REMARKS

Claims 1 - 13 are pending, with claims 2 - 6, and 8 - 13 having been withdrawn from consideration as drawn to a non-elected invention.

Fig. 7(a)

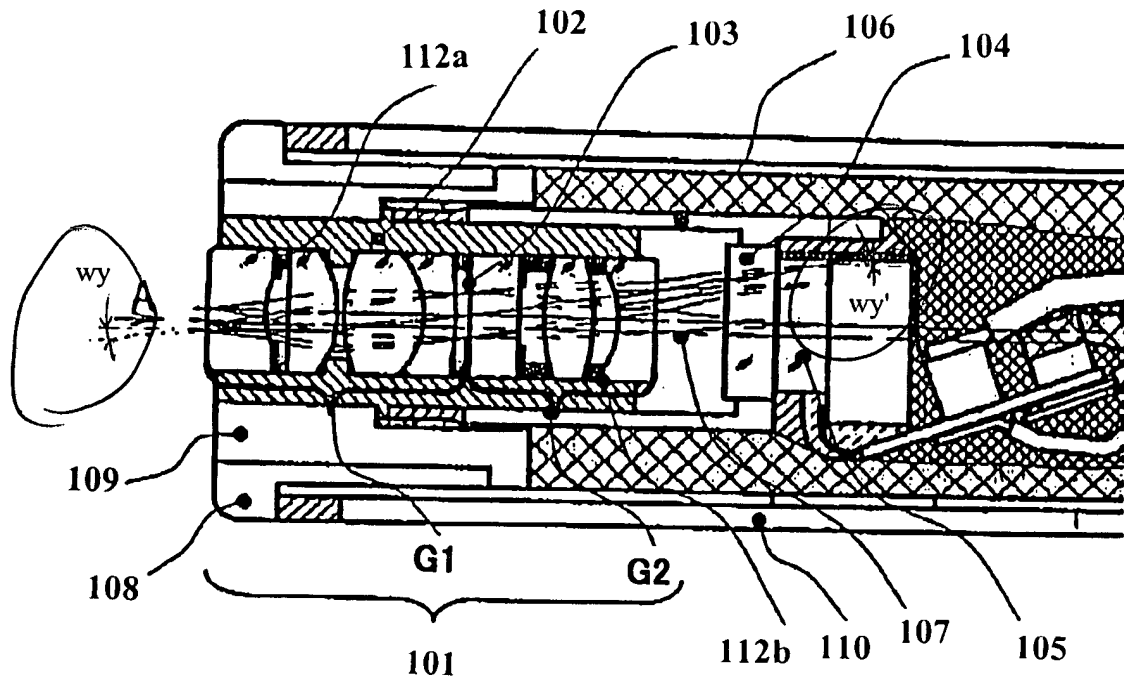
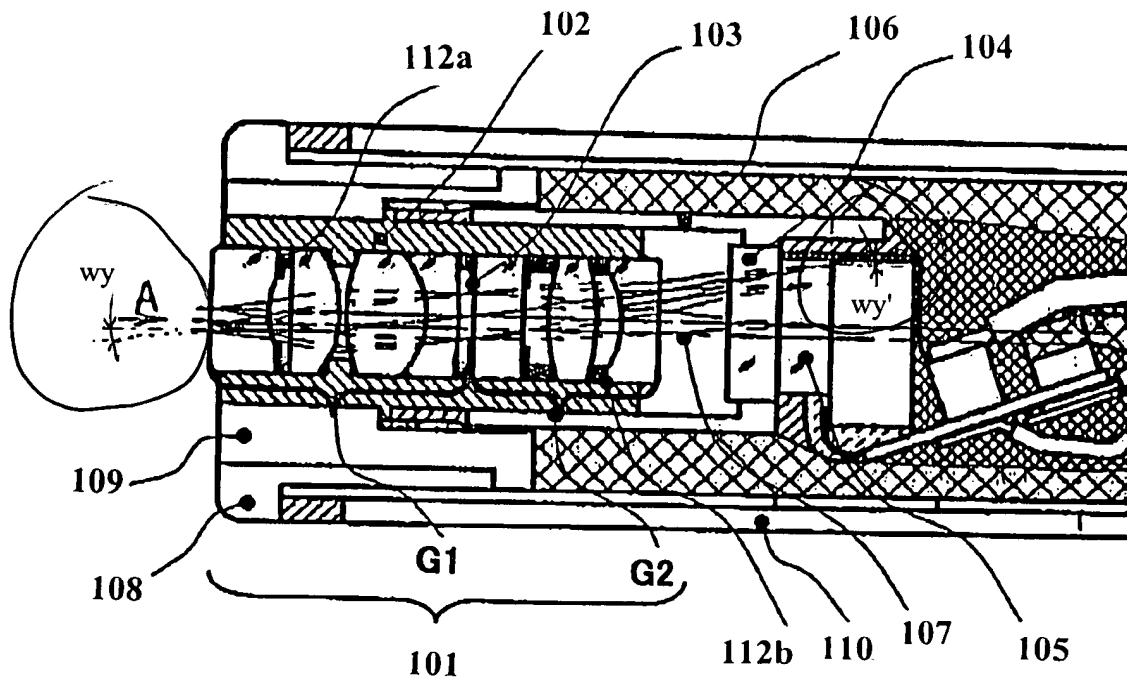
The drawings stand objected to under 37 CFR 1.83(a) for not illustrating “the chief ray corresponding to the largest half-field angle” and the “half-field angle of a ray incident onto the image pickup surface”. In response to this objection, the Office Draftsperson has been requested to enter replacement drawing sheets 1 - 8 in lieu of the drawing sheets 1 - 7 as originally filed. The requested changes to the drawing figures are as follows: in Fig. 7(a) the symbols wy and wy' have been added in order to illustrate that which was claimed in claim 1 as filed. Also, Fig. 7(c) has been added to show an enlarged view of the lens portion of Fig. 7(a) in order to more clearly indicate the angles wy and wy' . The above changes to the drawings are believed to **not** constitute “new matter”, since the symbols wy and wy' were described in the disclosure as filed, and Figs. 7(a) and 7(c) merely make clear in the replacement drawings that which was adequately described in the disclosure as filed.

Claims 1 and 7 stand rejected under 35 U.S.C. 112, first paragraph, as failing to comply with the written description requirement, on the basis that claims 1 and 7 contain subject matter which was not described in the specification in such a way as to reasonably convey to one skilled in the relevant art that applicant had possession of the claimed invention. More specifically, the Examiner states that the angle wy' (which is described in the disclosure as filed as being “the angle at which the chief ray corresponding to the largest half-field angle is incident onto the image pickup surface”) and the angle wy (which is described in the disclosure as filed as being “the half-field angle of a ray incident onto the image pickup surface”) are not adequately described in the disclosure as filed. Reconsideration of this rejection is respectfully requested. From viewing Figs. 7(a) and 7(c) of the replacement drawing sheets, it is respectfully submitted

Claims 1 and 7 stand rejected under 35 U.S.C. 112, second paragraph, as being indefinite, on the basis that “they are not adequately described in the specification and figures, as noted above”. Reconsideration of this rejection is respectfully requested on the basis that, with the aid of the substitute drawings, one of ordinary skill in the art would know how to measure the angles wy' and wy . Whereas the angle wy' is the angle at which the chief ray corresponding to the largest half-field angle is incident onto the image pickup surface, the angle wy is the half-field angle of a ray incident onto the image pickup surface, as measured on the object side of optical system. Although admittedly, this was not clear from the definition alone as filed, it is submitted that clarifying this issue (via the angles wy and wy' being illustrated in the drawings) does not comprise “new matter” for the following reasons:

(1) clarified in the drawings how the angles wy and wy' are measured, without adding new matter,

(4) described in the specification and figures, without adding new matter, the manner in which wy and wy' are measured,

Fig. 7(c)

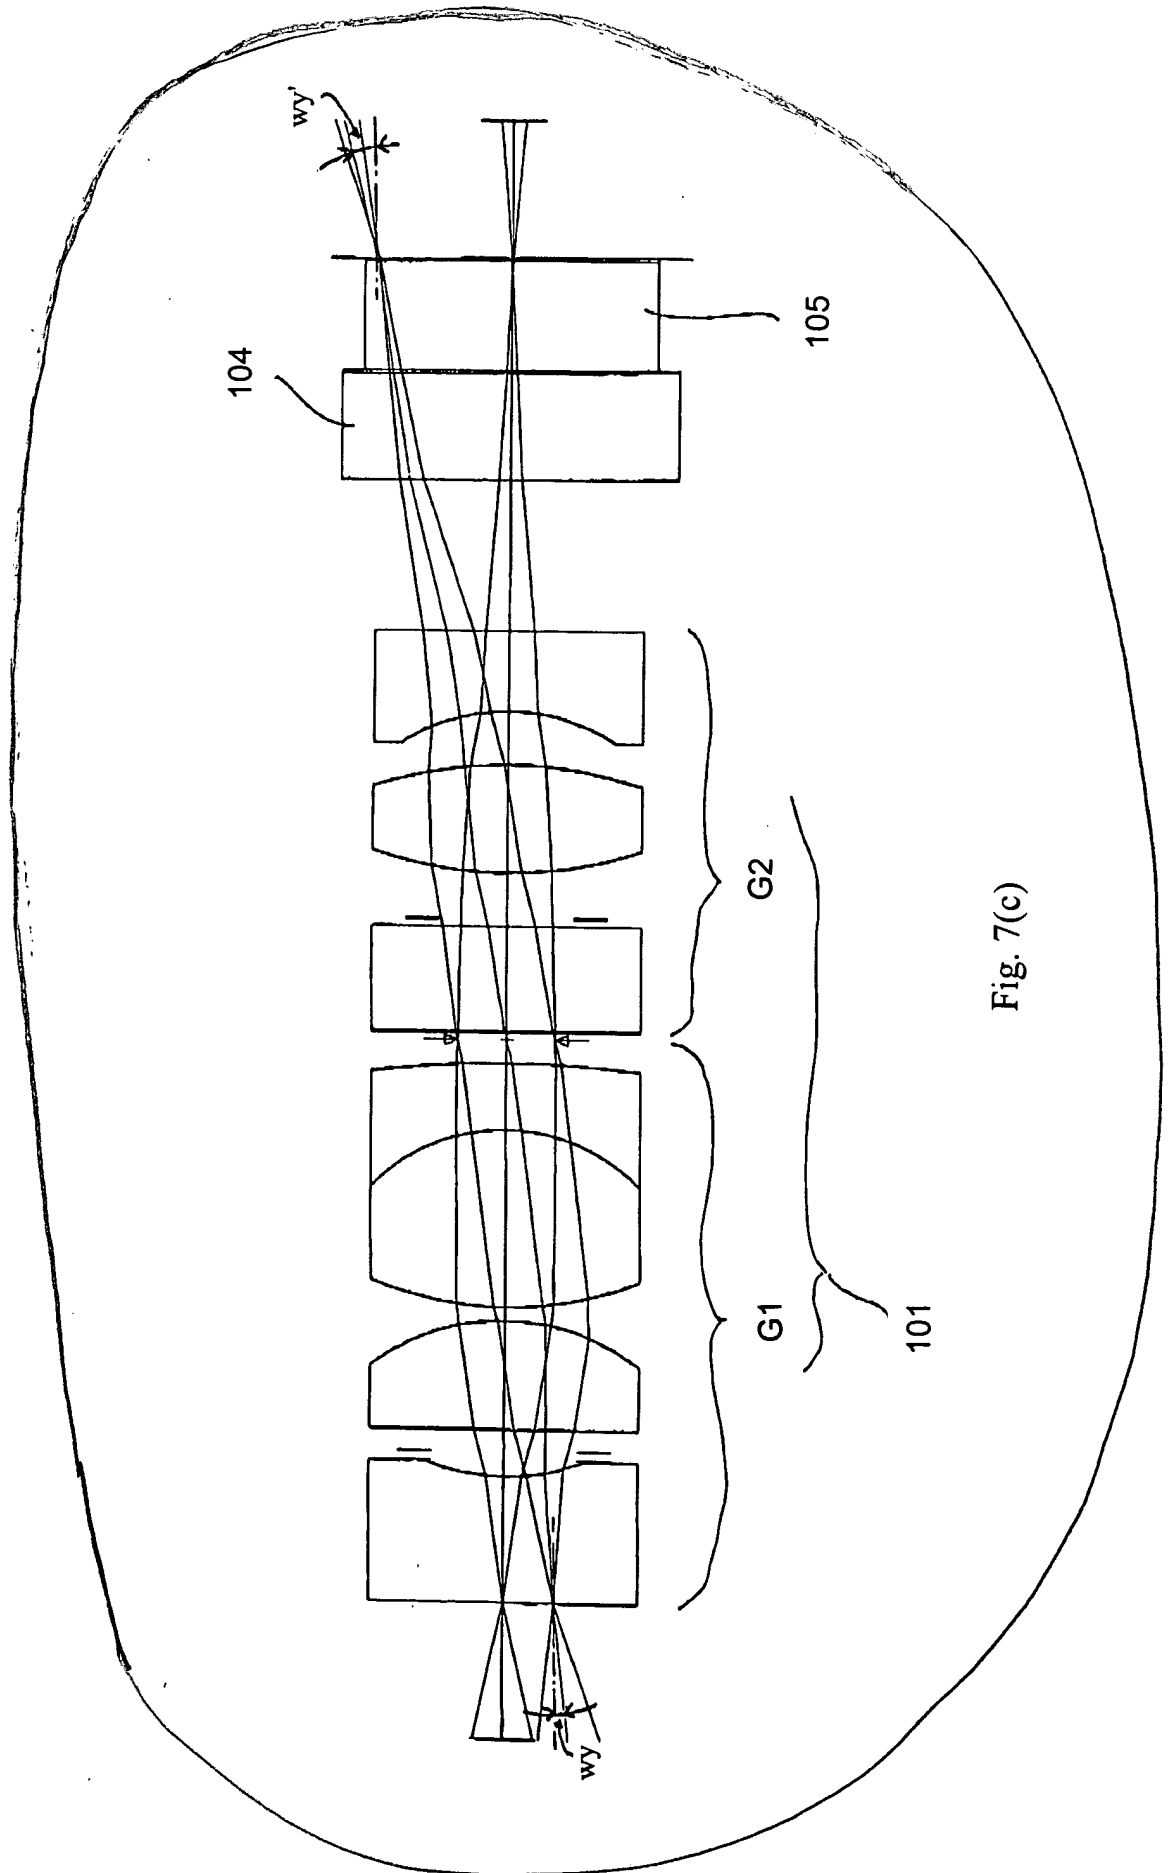
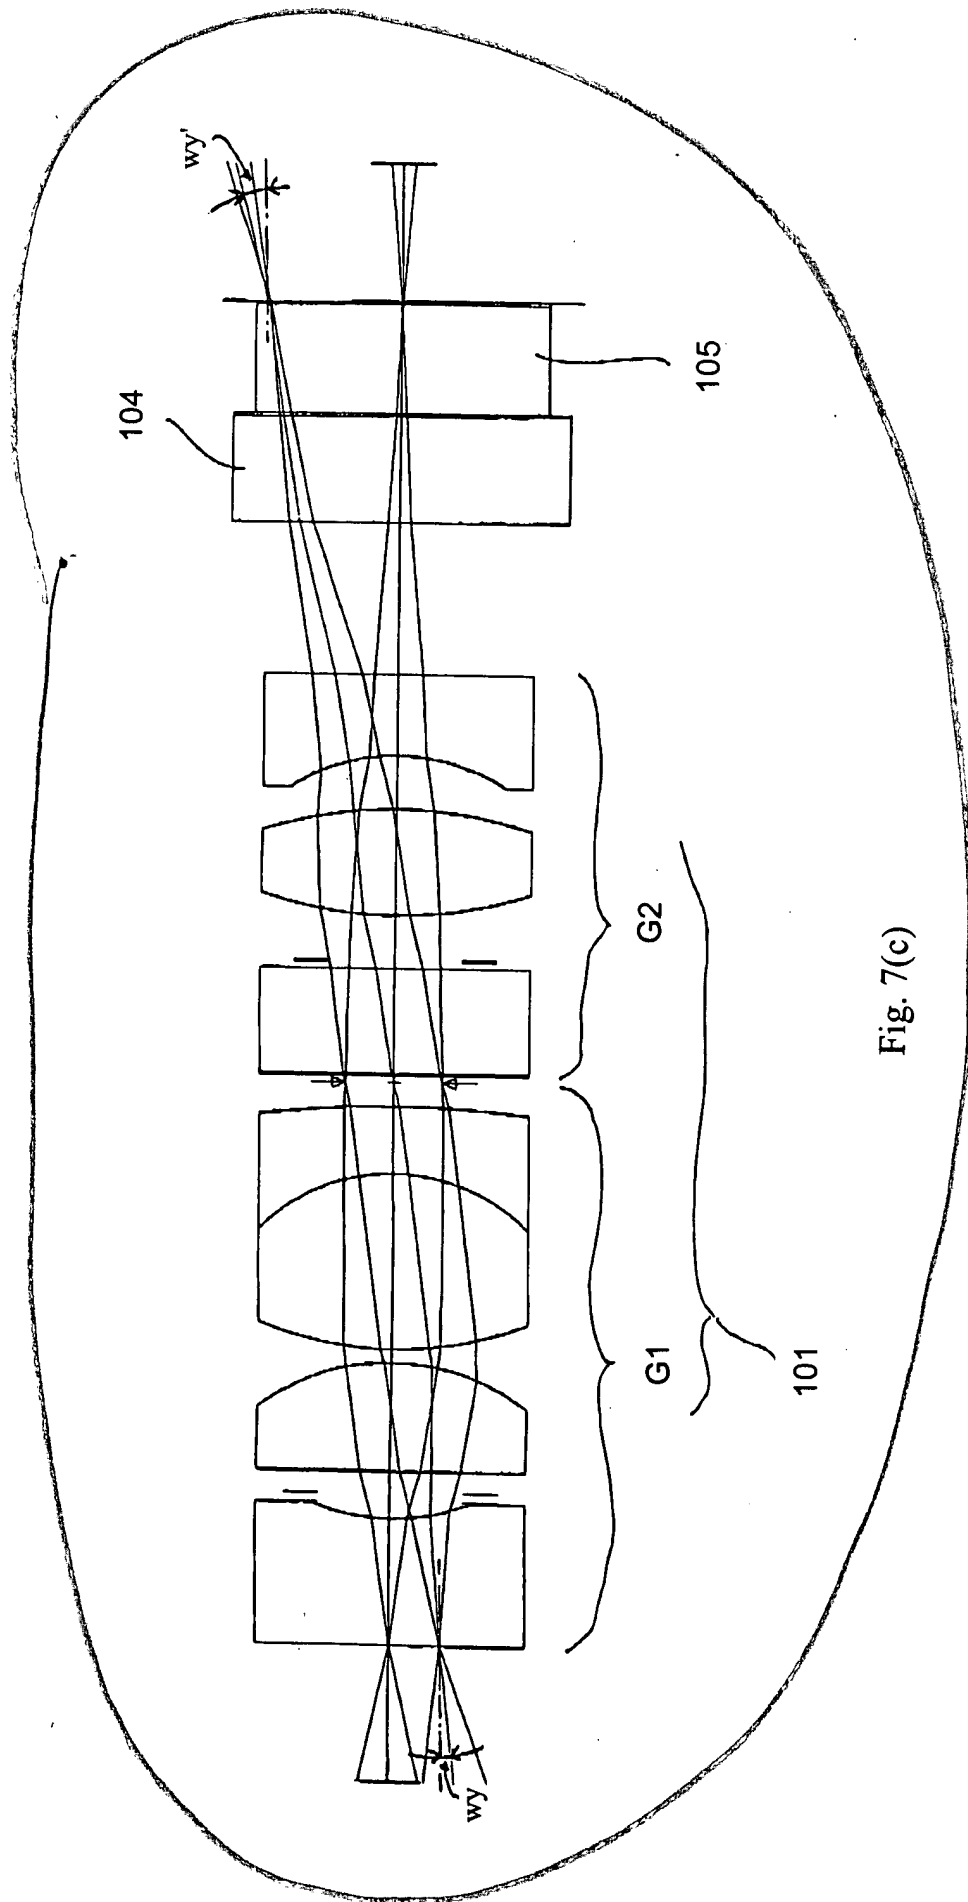
The specification has been amended above at page 6 so as to refer to Figs. 7(a) - 7(c) in lieu of the description in the specification as filed that referred to Figs. 7(a) and 7(b). Also, Table 3 has been amended to refer to the ‘chief ray’ rather than to the - - main ray - - .
